### Proposed Revisions to a Standard Plans Index

Index Number: 521-600

Index Title: MSE Wall Coping (Precast or C-I-P)

**Summary of the changes:**

SECTION B-B  
PRECAST COPING

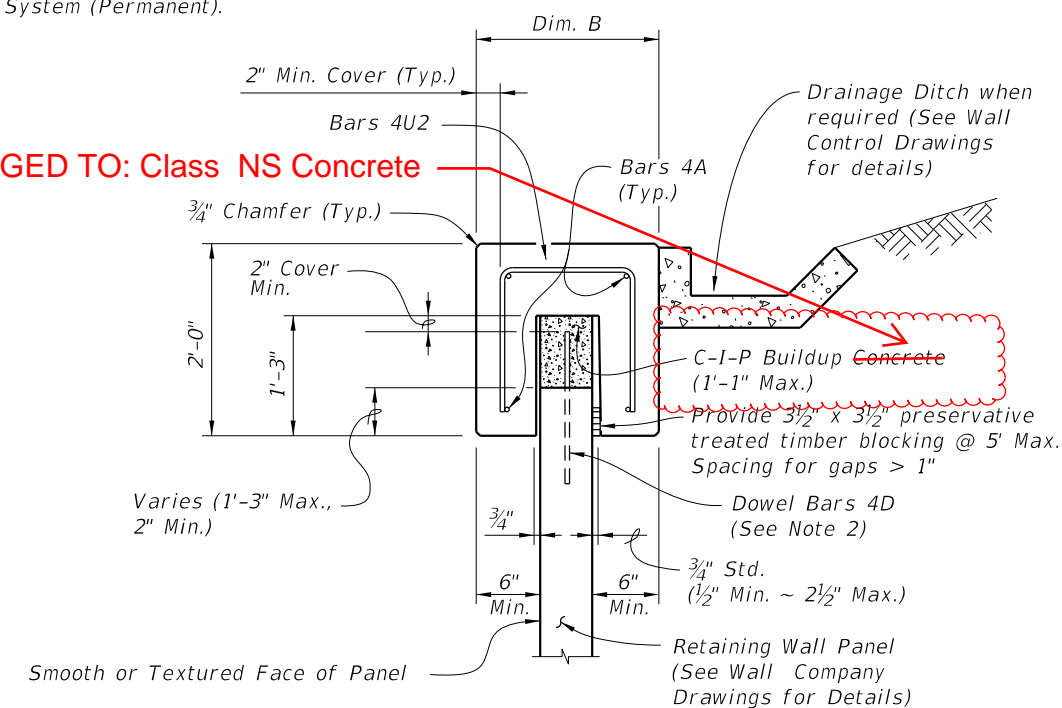
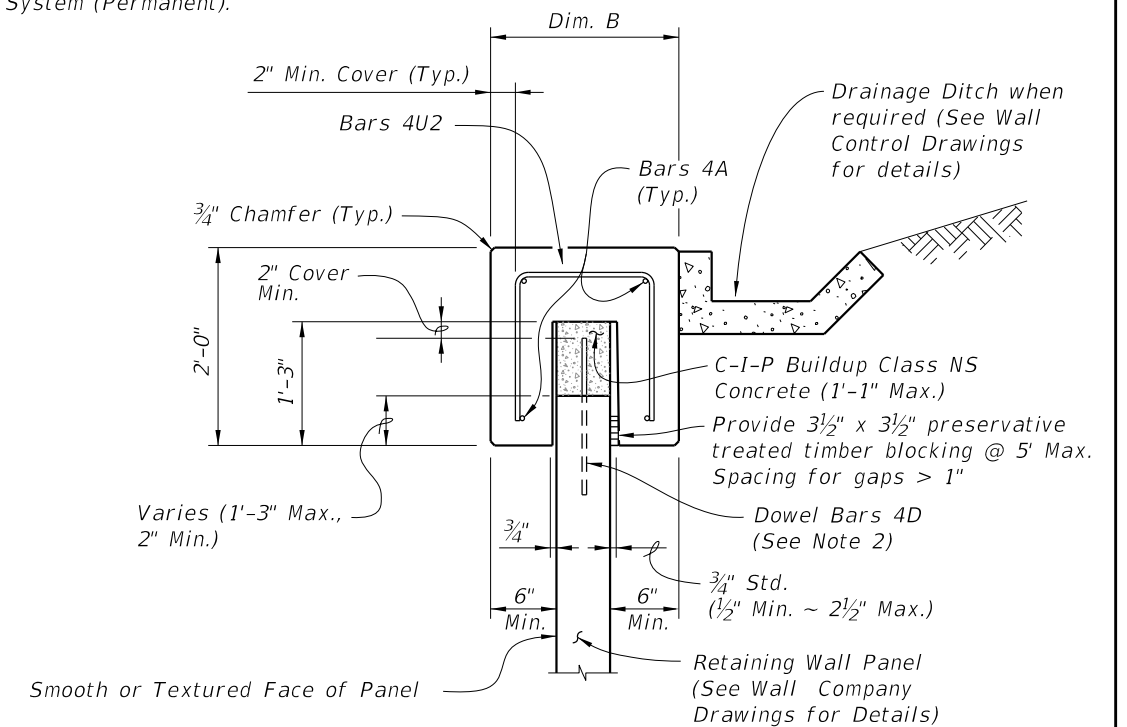
Changed C-I-P Buildup Concrete (1'-1" Max.) callout in the PRECAST COPING SECTION B-B to C-I-P Class NS Concrete (1'-1" Max.).

CIP buildup concrete type was never clarified. SDO review deems Class NS is acceptable because the concrete buildup section is not meant to transfer any meaningful load to the wall other than self weight.

**CHANGED TO: Class NS Concrete**
